Access Compliance Report

Public Rights-of-Way

(Curb Ramps)

Intersection ID: 9962	Main Street: LITTLE ROCK RD	Cross Street: TUCKASEEGEE RD	Location:	N
ADA ID: 26068396B086	Ramp Type: BlendTrans1	Initial Pass/Fail: Fail	Overall Compliance: No	Severity Score: 8.75
Codes/Mitigation Info/Possible Solution		Field Measurements/Component Compliance

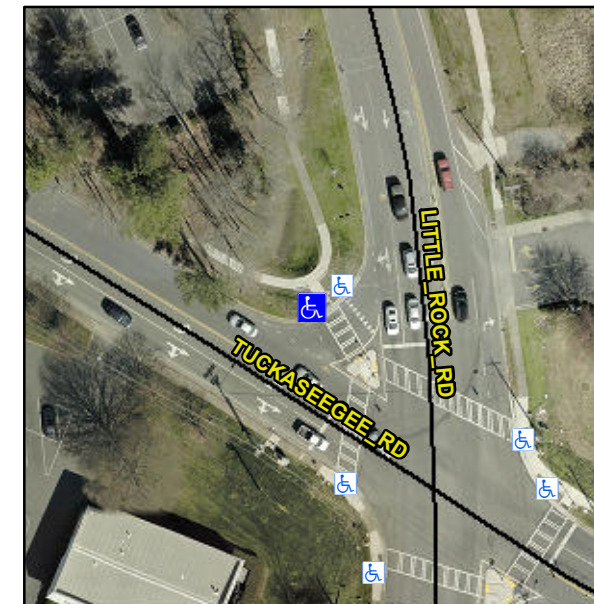
Not Found, R304.5.1

Compliance	Description	Data	Compliance	Description	Data
N/A	Ramp Length (in)	53.0	Yes	BlendTrans Slope (%)	2.3
No	Ramp Width (in)	47.0	Yes	BlendTrans XSlope (%)	0.9
N/A	Flare Type LT	N/A	N/A	Flare Type RT	N/A
N/A	Flare Slope LT (%)	N/A	N/A	Flare Slope RT (%)	N/A
N/A	Flare Traversable LT?	N/A	N/A	Flare Traversable RT?	N/A
N/A	Landing Length (in)	N/A	N/A	DWS Provided?	N/A
N/A	Landing Width (in)	N/A	N/A	DWS Contrast?	N/A
N/A	Landing Slope (%)	N/A	N/A	DWS Length (in)	N/A
N/A	Landing X Slope (%)	N/A	N/A	DWS Full Width?	N/A
N/A	Landing Curb? (Y/N)	N/A	N/A	DWS Offset (in)	N/A
N/A	Shared Landing?	N/A			
N/A	Gutter Ponding?	N/A	N/A	Gutter Slope (%)	N/A
N/A	Gutter Lip Ht (in)	N/A	N/A	Gutter X Slope (%)	N/A
N/A	Painted X Walk1?	No	N/A	Painted X Walk2?	N/A
	X Walk 1 Direction	To S		X Walk 2 Direction	N/A
	X Walk 1 Width (in)	N/A		X Walk 2 Width (in)	N/A
	X Walk 1 Slope (%)	1.8		X Walk 2 Slope (%)	N/A
	X Walk 1 X Slope (%)	1.8		X Walk 2 X Slope (%)	N/A

N/A	Ramp inside XWalk1?	N/A	N/A	Ramp inside XWalk2?	N/A
	Road Slope (%)	1.8		Clear Space?	N/A
	Road X Slope (%)	1.8	N/A	Clear Space to XWalk (in)	N/A
N/A	Any Obstructions?	N/A	N/A	Storm Grate/Utility Hazard?	N/A
	Obstruction Type			Storm Grate/Utility Type	
		N/A			N/A
			Yes	Surface Condition? (G/P)	Good
			No	Curb Slope (%)	15.1

Remove & Replace Curb Ramp With Two New Directional Ramps or Equivalent.
